CITY OF CODY
PLANNING, ZONING AND ADJUSTMENT BOARD
TUESDAY, FEBRUARY 11, 2014
CITY HALL COUNCIL CHAMBERS @ 12:00 NOON

**CITY OF CODY
PLANNING, ZONING AND ADJUSTMENT BOARD
STAFF REPORT**

**CITY OF CODY
PLANNING, ZONING AND ADJUSTMENT BOARD
STAFF REPORT**

MEETING DATE:	FEBRUARY 11, 2014	TYPE OF ACTION NEEDED	
AGENDA ITEM:		P&Z BOARD APPROVAL:	X
SUBJECT:	SITE PLAN REVIEW: TRACTOR SUPPLY COMPANY. SPR 2014-02	RECOMMENDATION TO COUNCIL:	
PREPARED BY:	TODD STOWELL, CITY PLANNER	DISCUSSION ONLY:

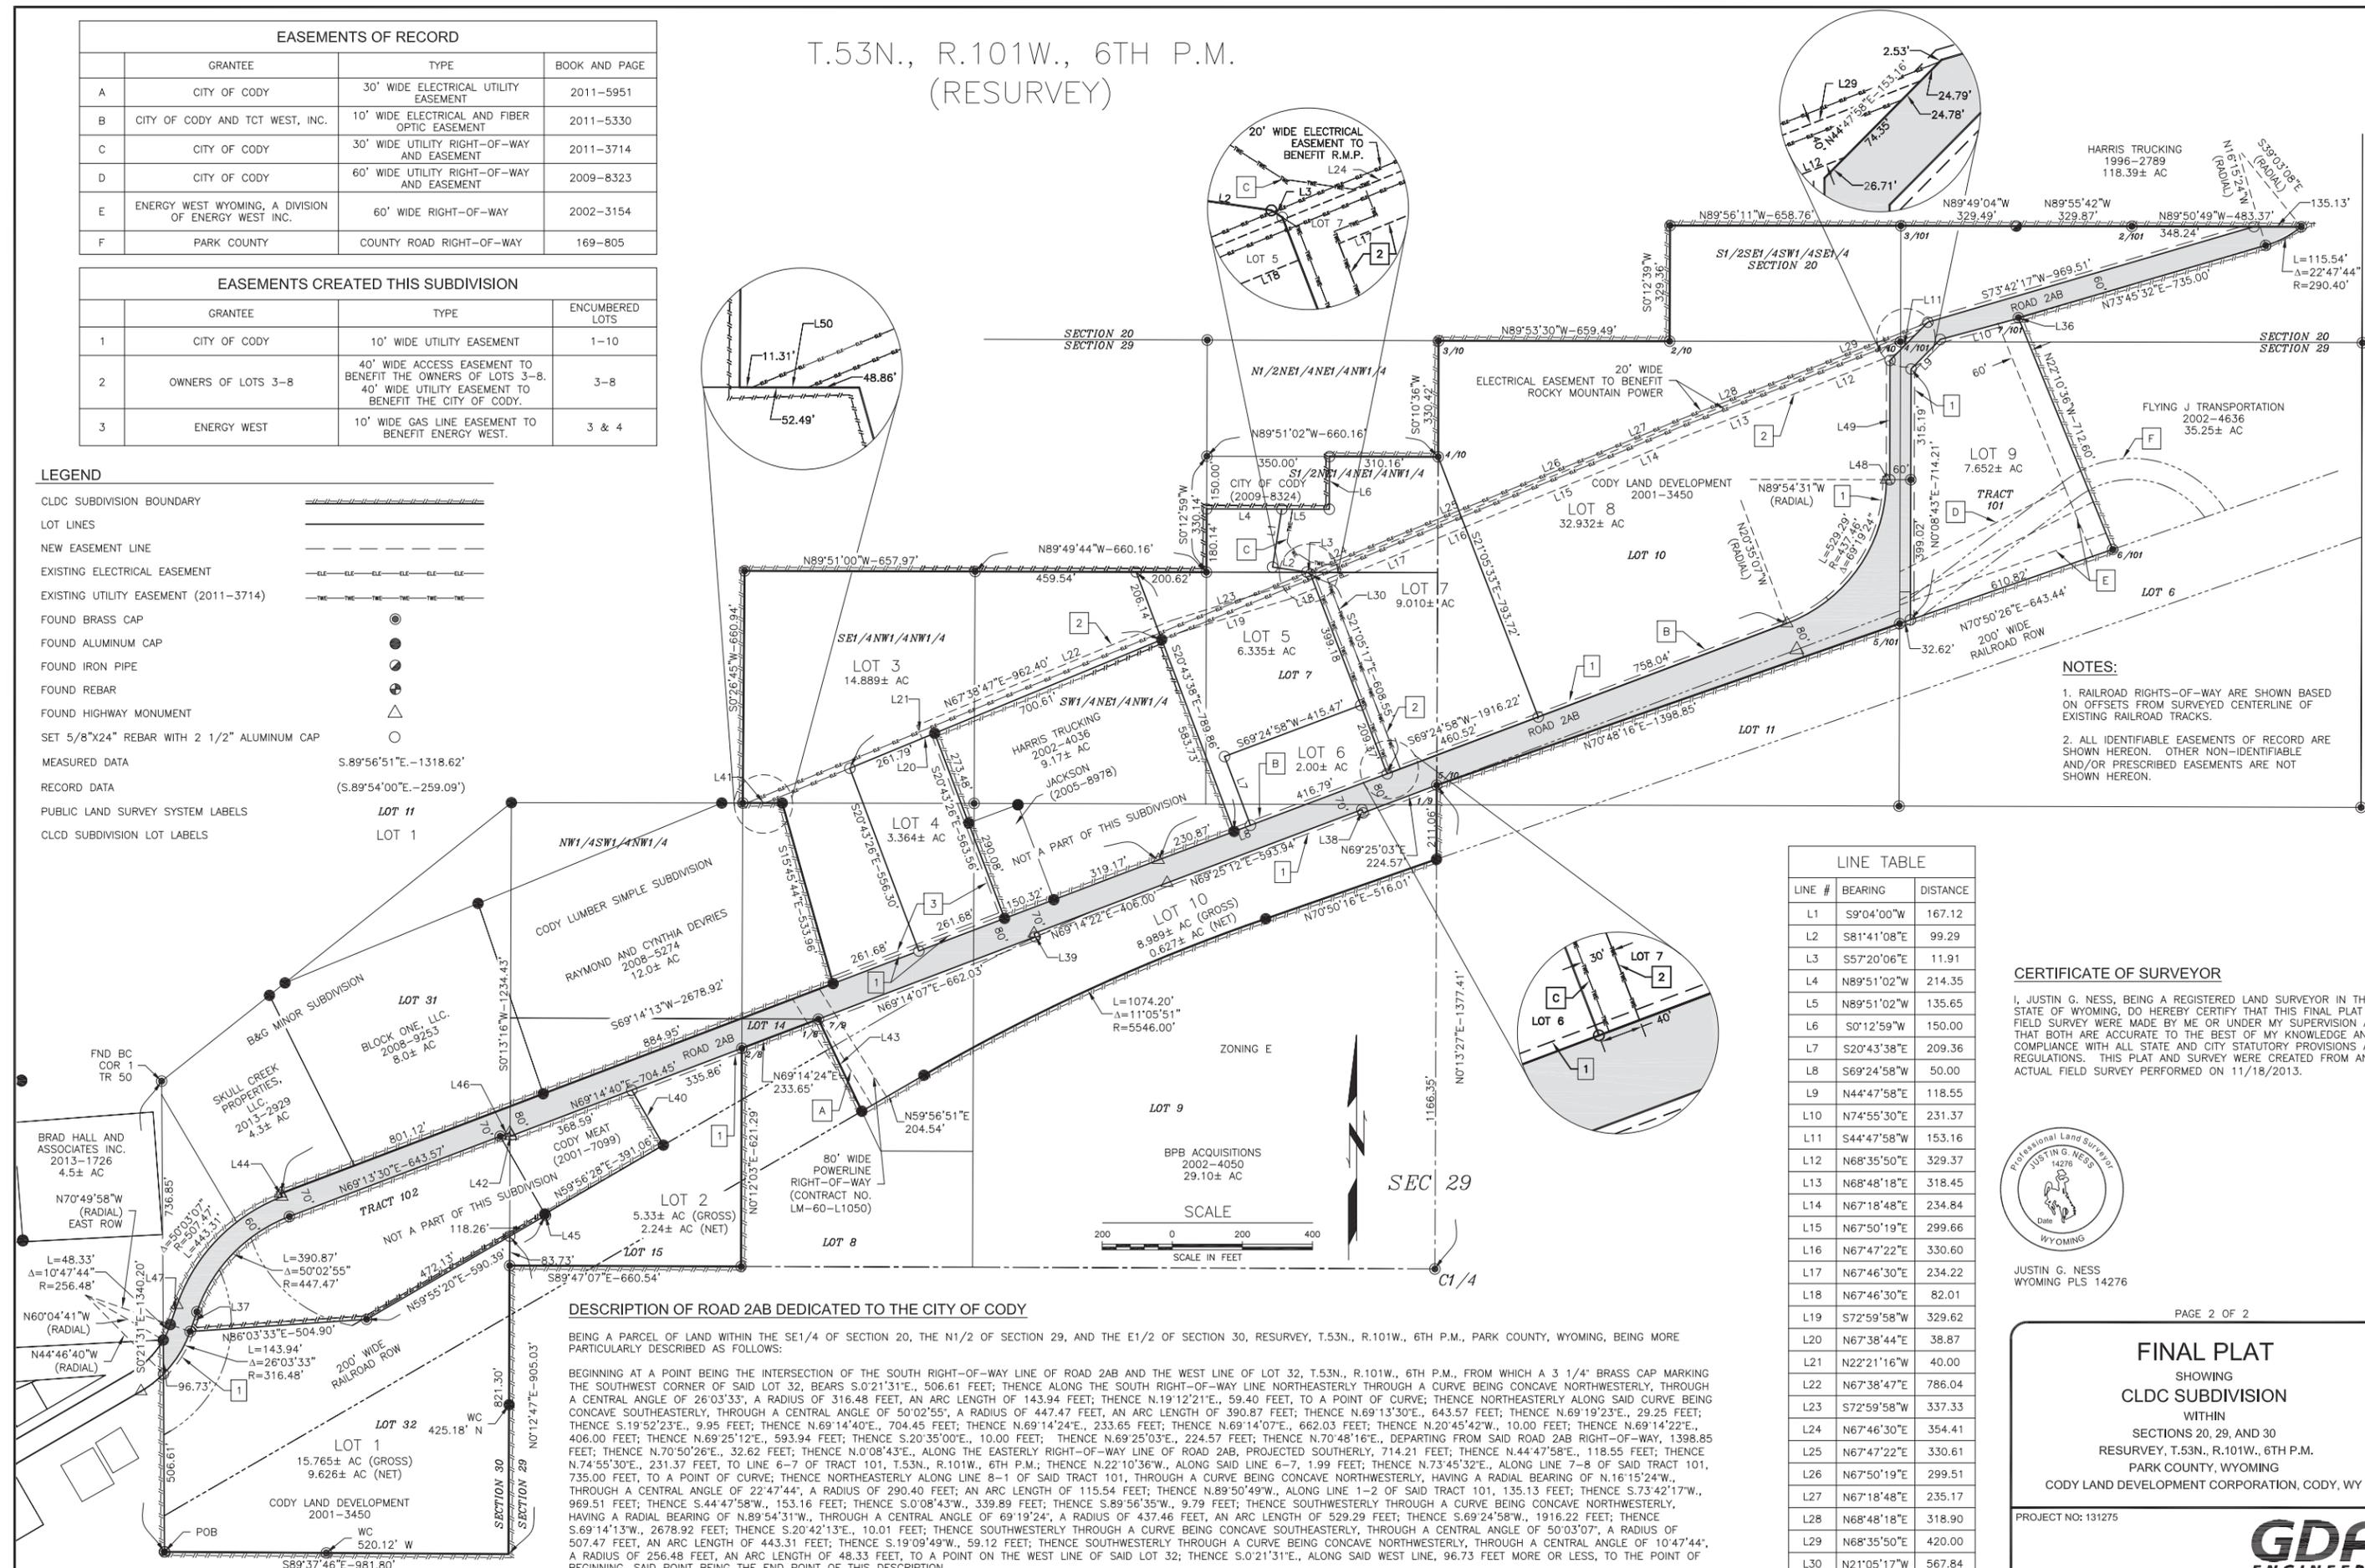
The final plat is slightly different from the approved version of the preliminary plat in the following ways:

- A. One lot has been eliminated: What were Lots 3 and 4 is now Lot 4, and Lot 10 was relabeled as Lot 3.
- B. Lot boundaries north of the Harris Trucking lot have been rearranged (Lot 5 now contains the hillside in that area).
- C. A new 10' natural gas easement is provided behind the 10' utility easement on the north side of 2AB (the natural gas line route is now planned along 2AB).
- D. The 40-foot access and utility easement (Easement 2) has been removed from the area west of the access road to the City water tower; the remaining 40-foot access and utility easement is now entirely south of the 20-foot Rocky Mountain Power easement (it was north of the power line).

DRAINAGE BASIN 1
 INFILTRATOR INLETS

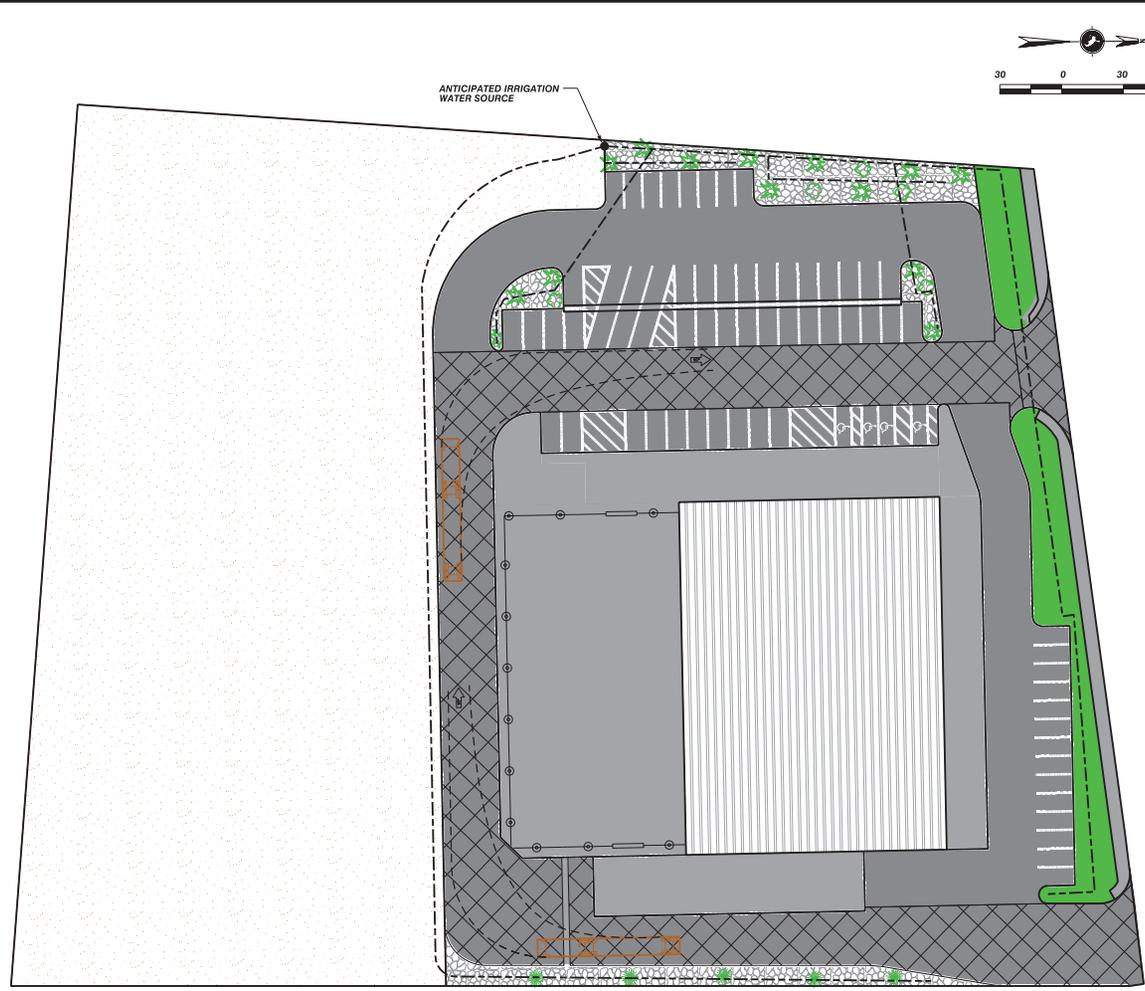
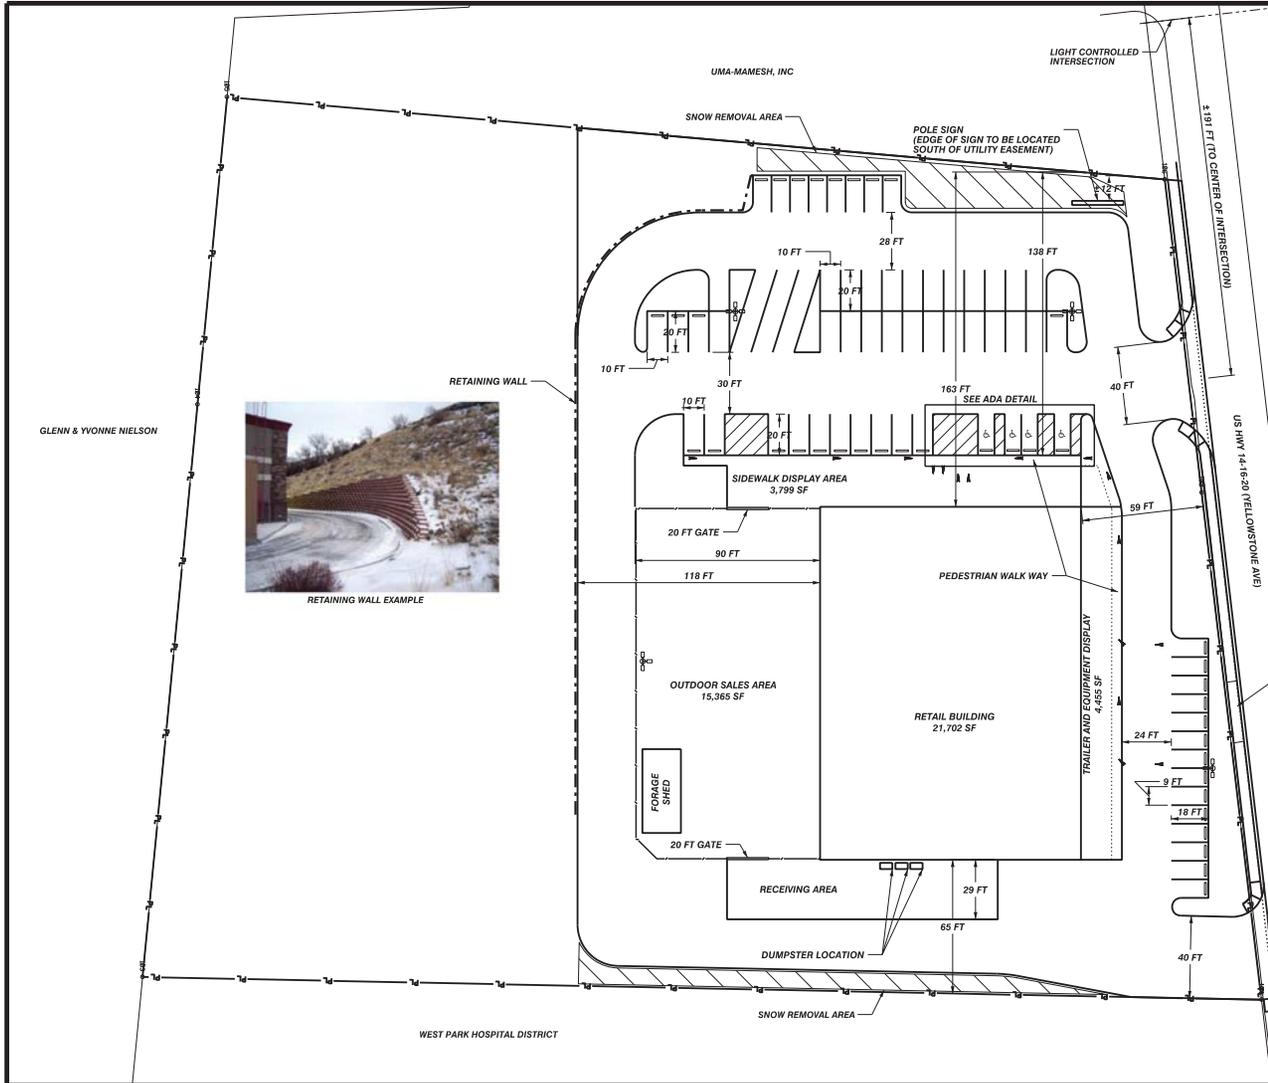
An engineered storm water plan has been submitted and reviewed by the City Engineer. The grading is properly designed to collect the storm water and retain it in accordance with the city storm water policy manual. The City Engineer does request that a second inlet be added to the infiltration trench in the northeast parking area, on the east end of the trench. Alternatively, but less desirable, the applicant's engineer may submit ponding data demonstrating that the one inlet is adequate to avoid ponding.

- a. The Storm Drainage Plan will not work for the existing utilities within the existing utility easement. For Perc Trench No. 3 the plans call for a 2.5 cut. This will intercept existing utilities. Also, we cannot have detained water over the top of a water main with only 3' of cover—no frost protection and the possibility of contamination of water in the event of a fire and a leak. This will also be a problem with Perc Trench No. 1.

Although we're not sure about the statements regarding the depths of cut, and the resulting cover over the top of the waterline and utilities, the percolation trench along the sidewalk on the north side will not be constructed as originally proposed. This area will be landscaped with lawn grass, eliminating the concern of storm water over the water main and reduction of cover over other utilities. In place of the percolation trench, underground infiltration chambers are proposed as shown on the revised drainage plan. Regarding Perc Trench No. 3, it is still proposed to be constructed essentially as originally proposed, south of the utility easement. There are no utilities in this area to our knowledge, and the existing inlet to the storm sewer needs to remain clear. If there are issues with this that we are not recognizing, please let us know.

Elevations added to the drainage plan.

SITE PLAN

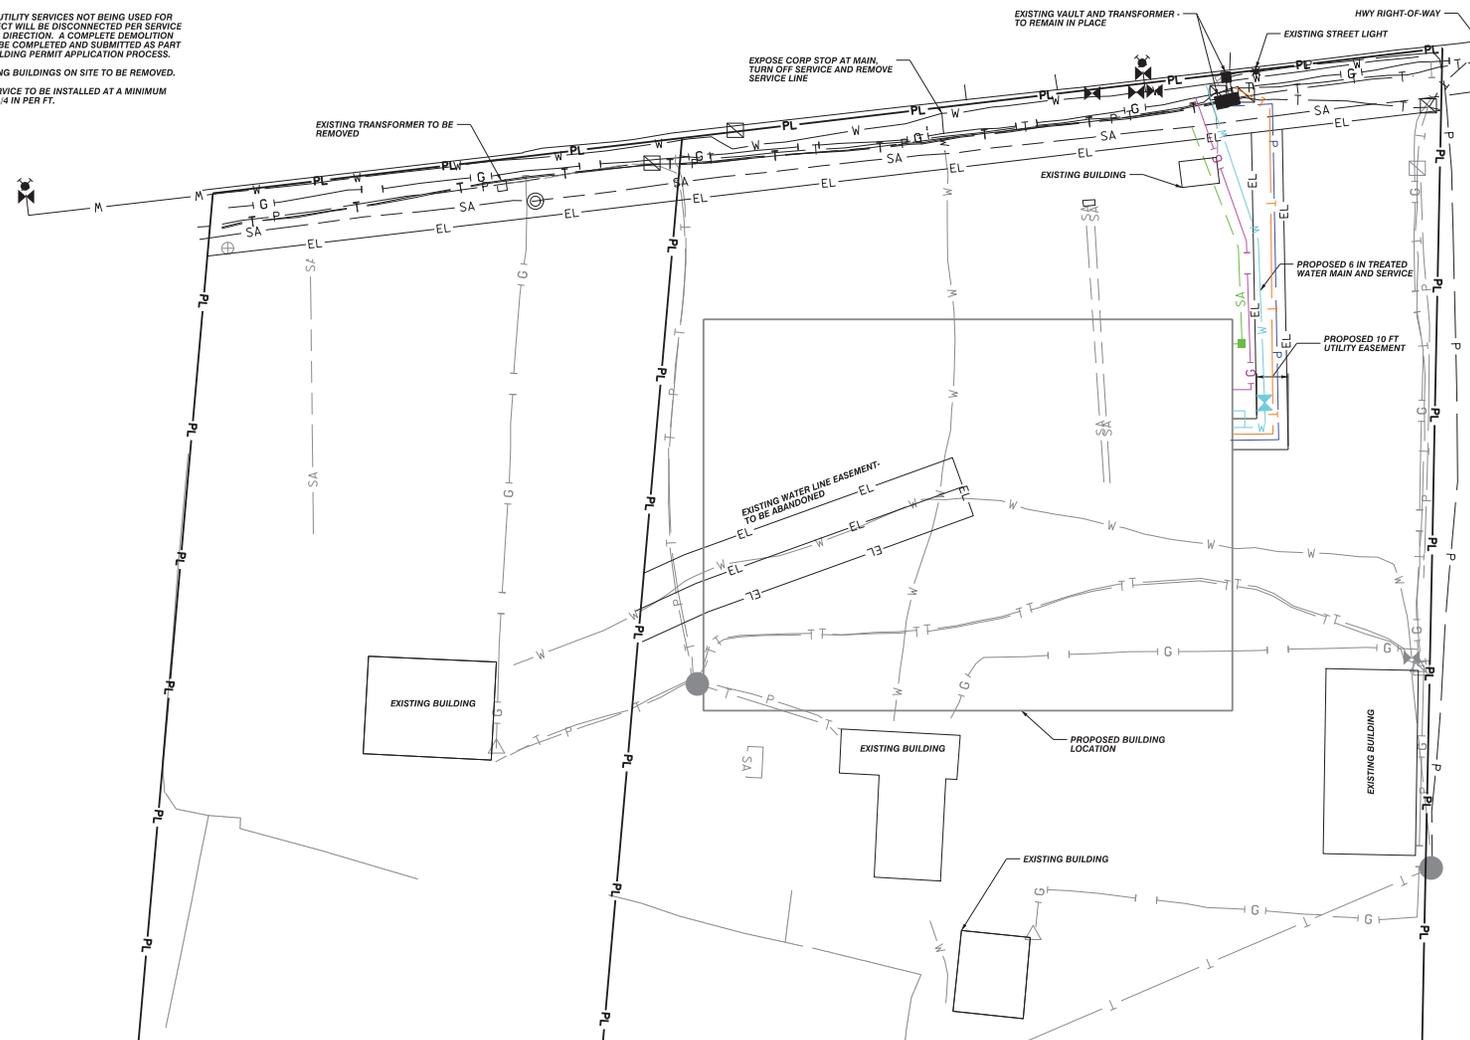
- a. Modify the striping in the ADA spaces to provide one Van Accessible space (11' wide).
- b. The 14 parking spaces along the frontage need to be extended in depth (towards the front) to provide eighteen feet from the back of the space to the wheel stop.

Other parking requirements, including illumination, surfacing, proximity to building, configuration, wheel stops, pedestrian access to building, circulation patterns, etc. are met. Stop signs at the exits should be shown on the site plans. Their location needs to be carefully coordinated with Public Works to avoid the utilities in the 20-foot utility easement along the front of the property.

An ADA detail has been added to the site plan.

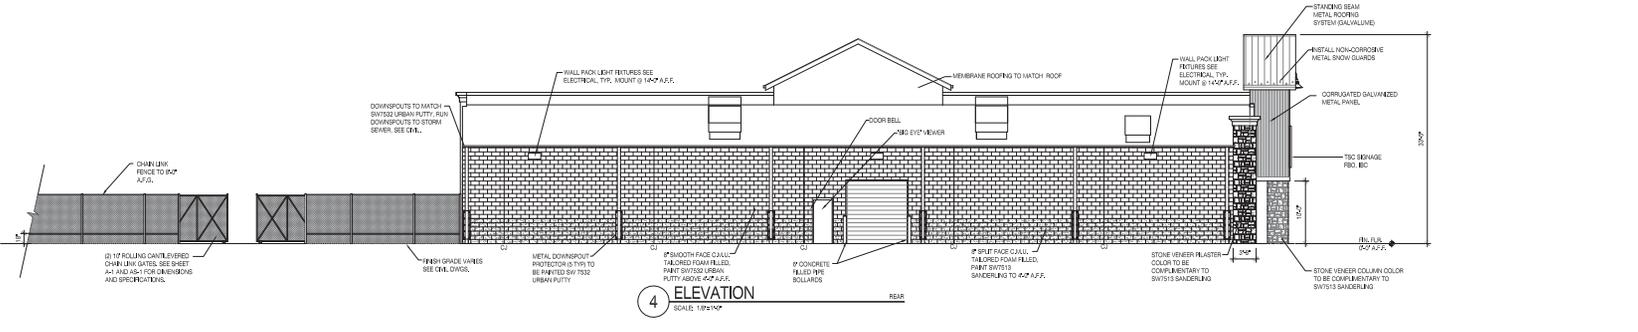
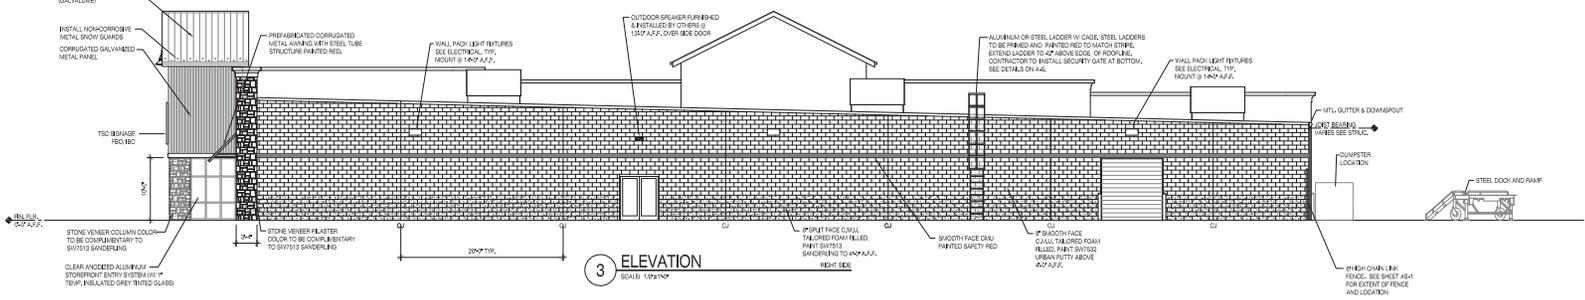
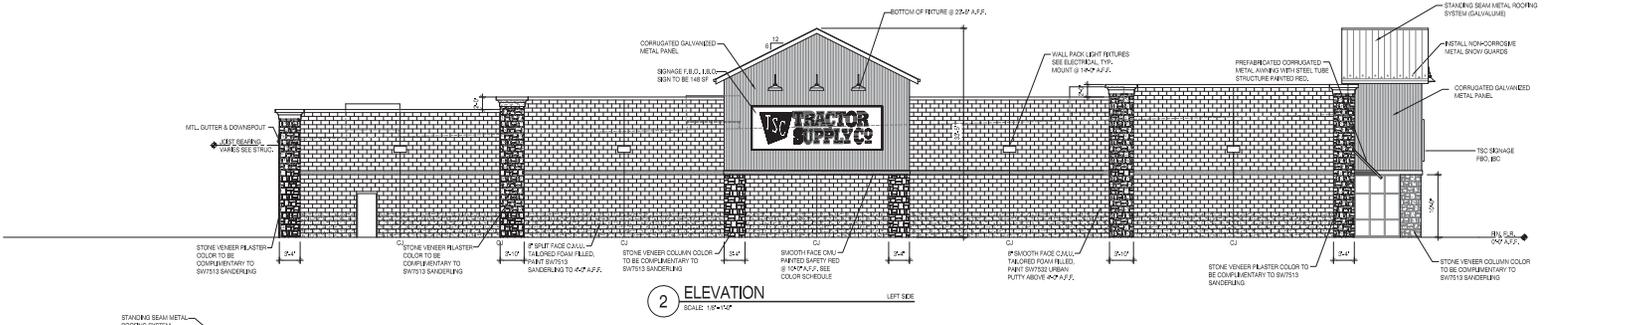
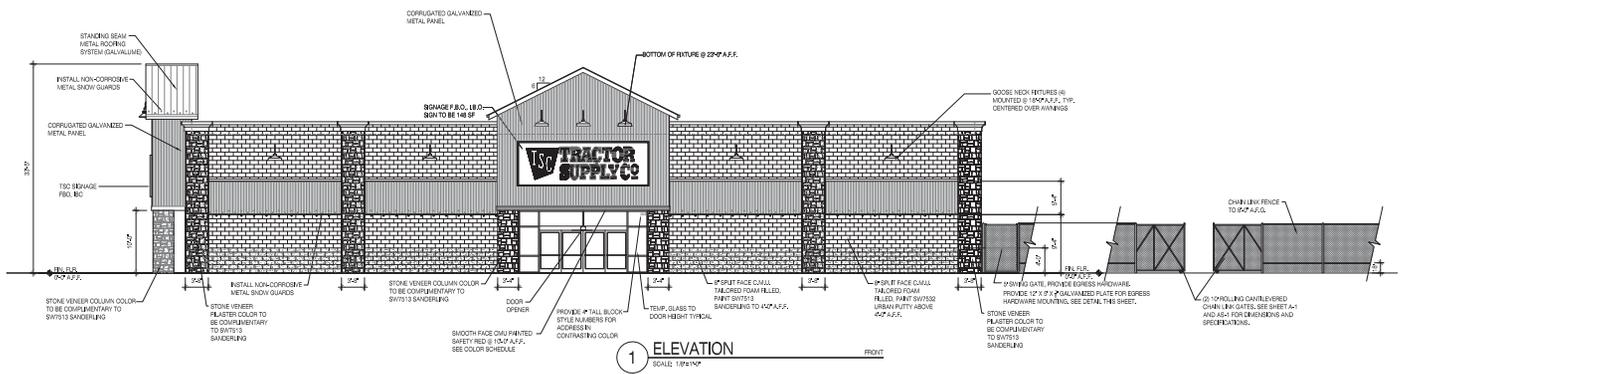
3. The building elevations provided are shown as "Example Elevations". Are these the actual elevations proposed? The alignment of the building places the main façade on the west side, leaving the architecturally void side of the building along the highway frontage and the rear of the building also highly visible from the highway and neighboring Cathcart medical center. The lack of architectural features on these two sides of the building is of concern to staff and may also be of concern to the Planning and Zoning Board. In early discussions we mentioned that with the size and location of the

facility on the city's west entry corridor, architectural compatibility is important. With neighboring structures such as the Cathcart medical center to the west, the architectural compatibility requirement would likely necessitate architectural enhancements above the basic standard. At that time, timber work and/or wainscot treatments were mentioned as likely options. If alternative building elevations are proposed, we need them for the Planning and Zoning Board review.

Please see revised elevations. In addition, trees are proposed to be planted along the percolation trench on the east property line providing screening of the delivery/loading area for the business.
